Report

3 Moore Street, Port Hedland - Dust Impact Assessment RFF Australia

Revision: 1.0 - DRAFT
Issued: 26 November 2013

Sketches Showing Openable and Fixed Openings.

PROJECT TITLE / CLIENT	PROPOSED DEVELOPMENT OF 9 MULTIPLE DWELLINGS
CHANGING TITLE	3 MOORE STREET - PORT HEDLAND
GROUND FLOOR PLAN	
DATE	25.10.13
SCALE	1:100
DRAWN BY	HAIR
CHECKED BY	1953 SKZ.01
DATE	25.10.13
SCALE	1:100
DRAWING NUMBER	1953 SKZ.01
REVISION	B

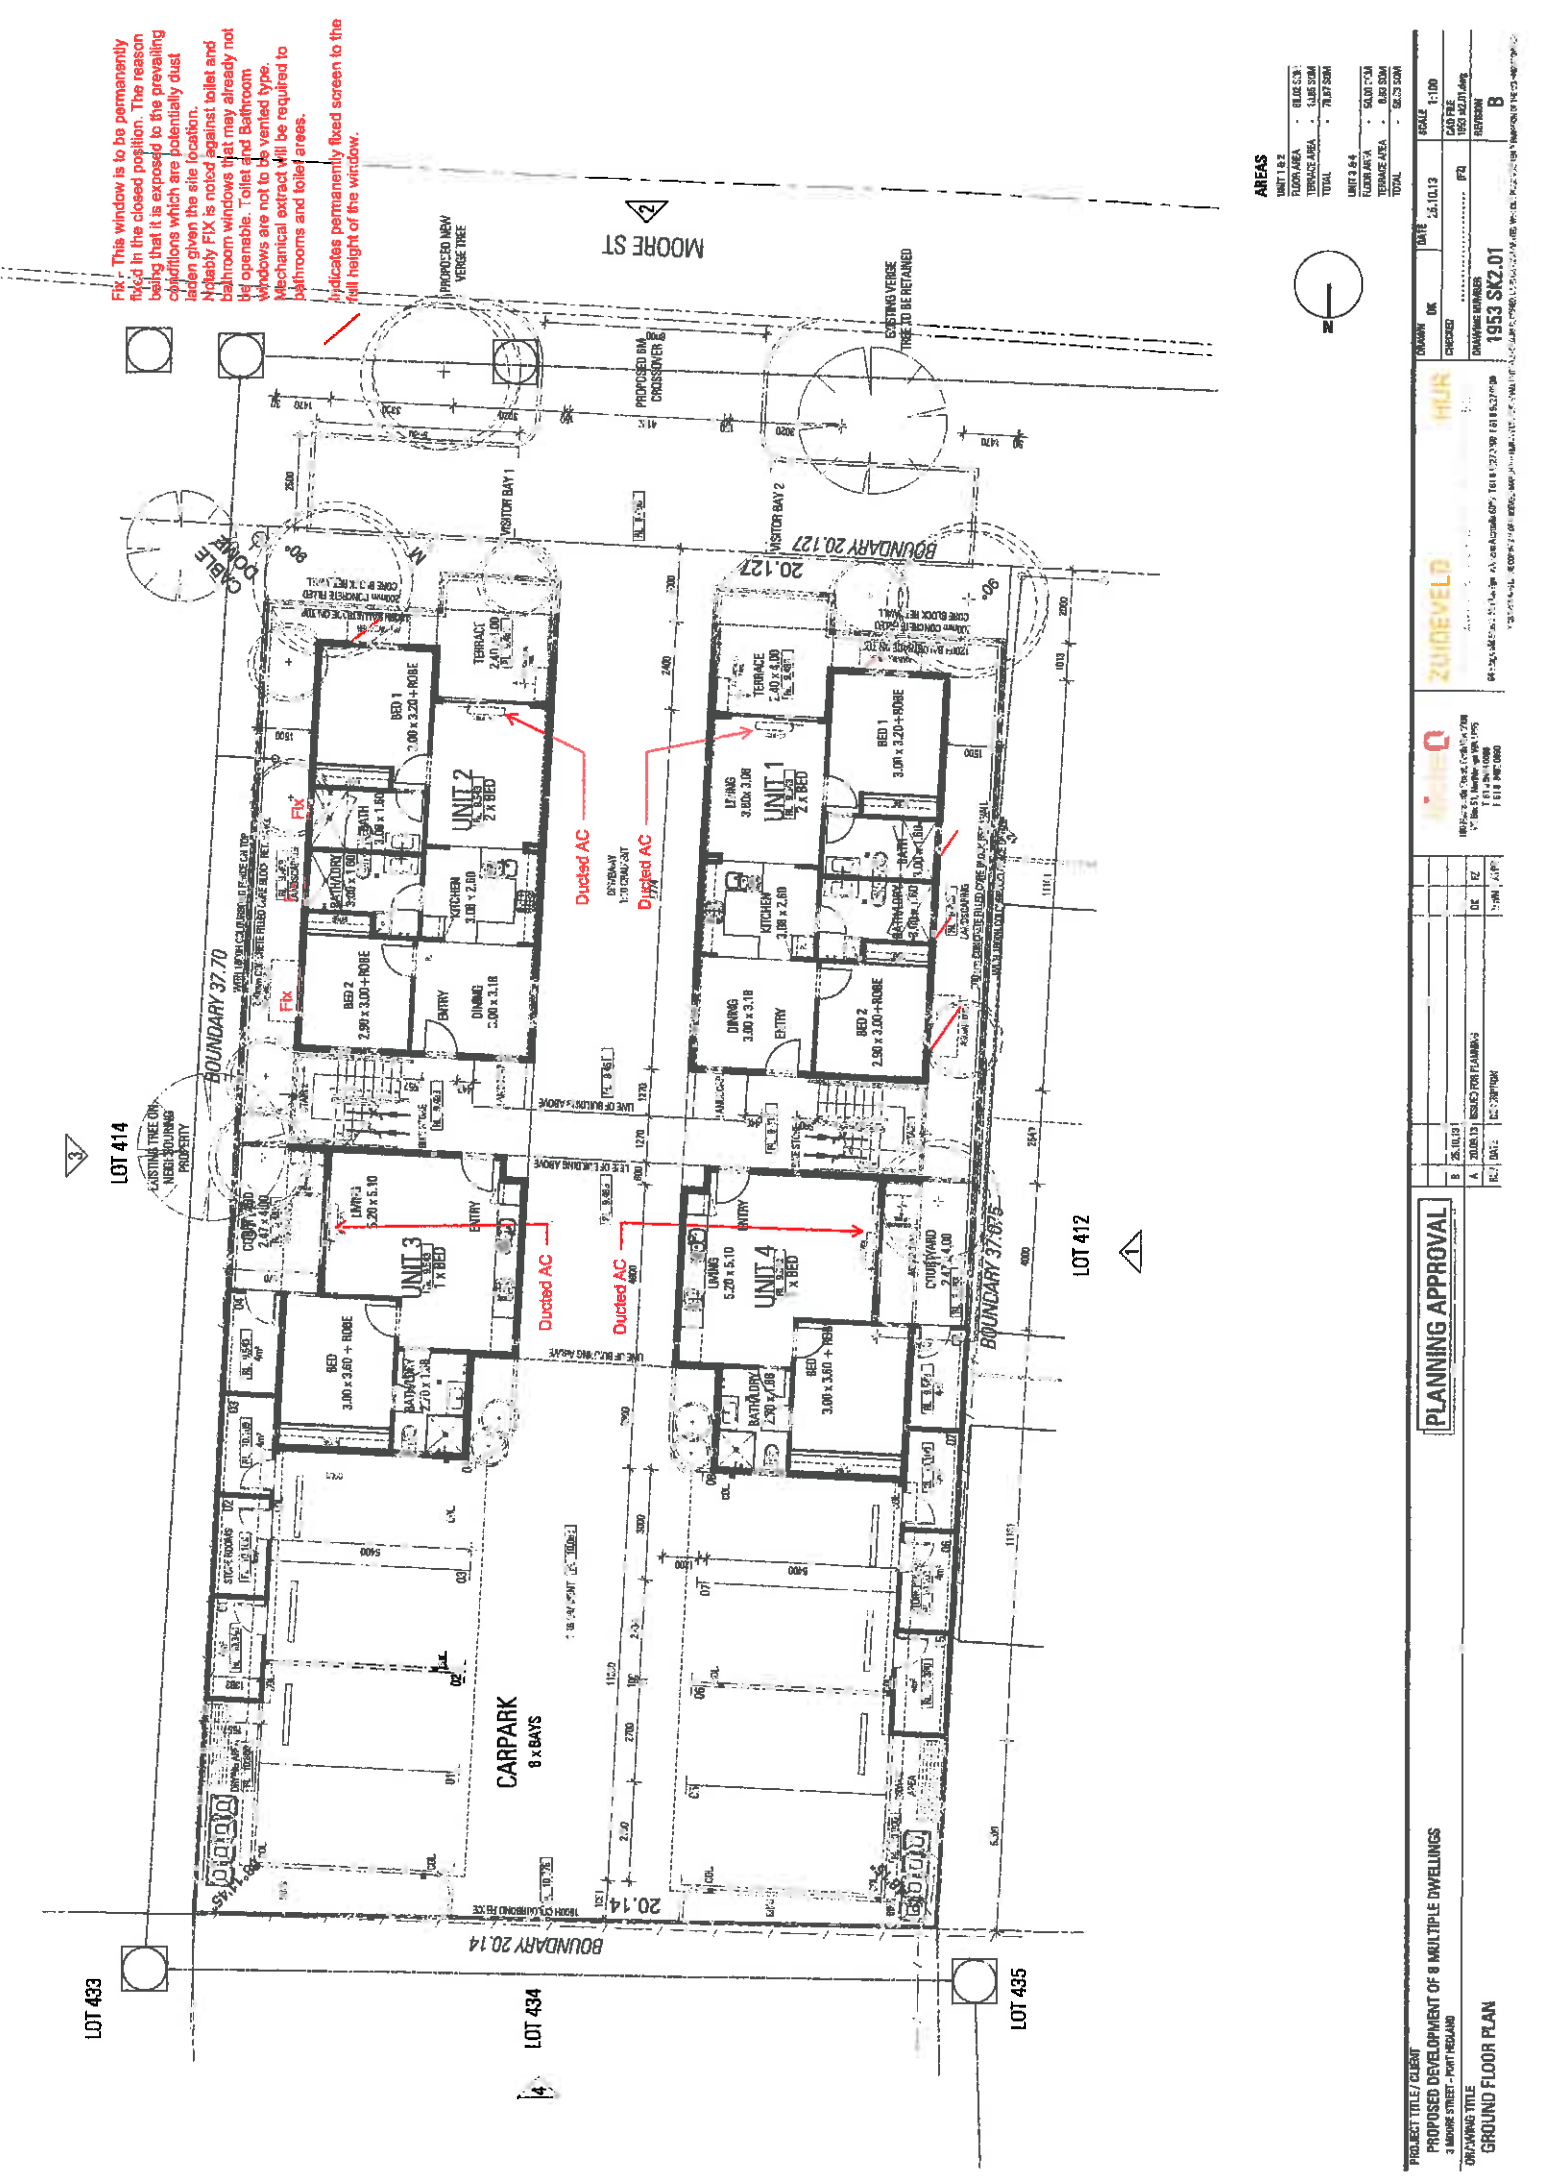
FX - This window is to be permanently fixed in the closed position. The reason being that it is exposed to the prevailing conditions which are potentially dust laden given the site location. Notably FX is noted against toilet and Bathroom windows that may already not be operable. Toilet and Bathroom windows are not to be vented type. Mechanical extract will be required to bathrooms and toilet areas.
 Indicates permanently fixed screen to the full height of the window.

DATE	25.10.13	SCALE	1:100
CHECKED		CAD FILE	1729_07_20.dwg
DRAWING NUMBER	1953 SK2.02	REVISION	B

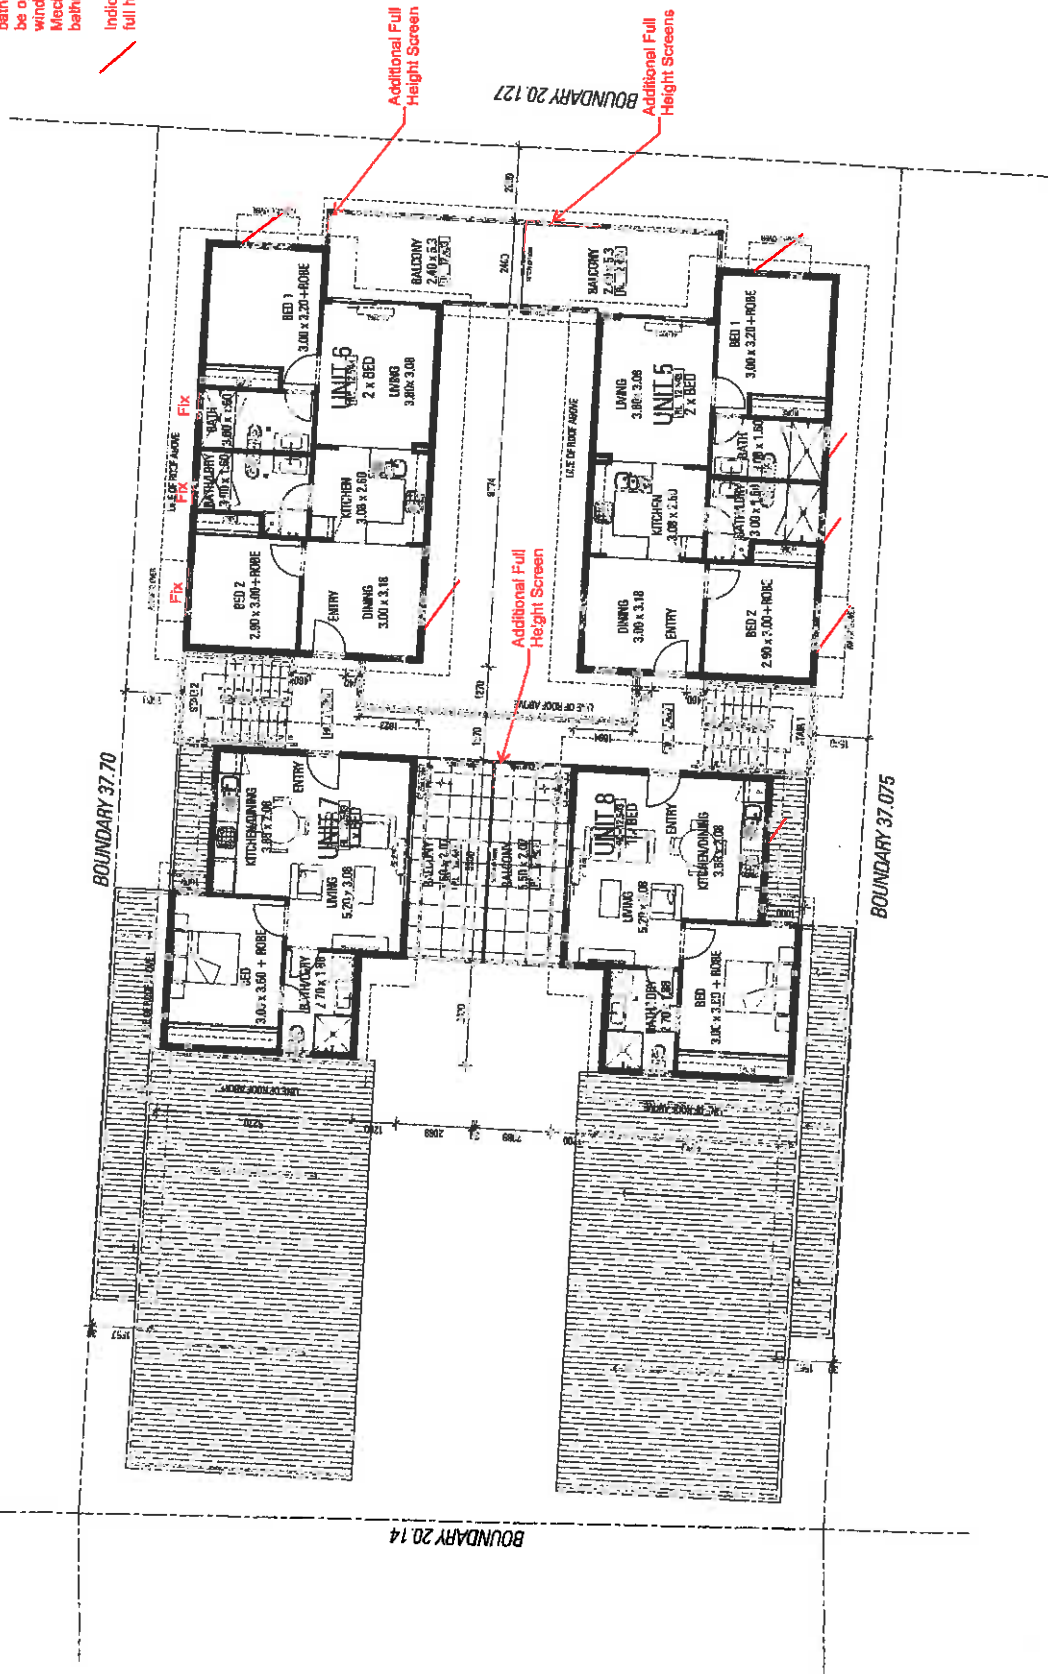
Fix - This window is to be permanently fixed in the closed position. The reason being that it is exposed to the prevailing conditions which are potentially dust laden given the site location. Notably FIX is noted against toilet and bathroom windows that may already not be operable. Toilet and Bathroom windows are not to be vented type. Mechanical extract will be required to bedrooms and toilet areas.

Indicates permanently fixed screen to the full height of the window.
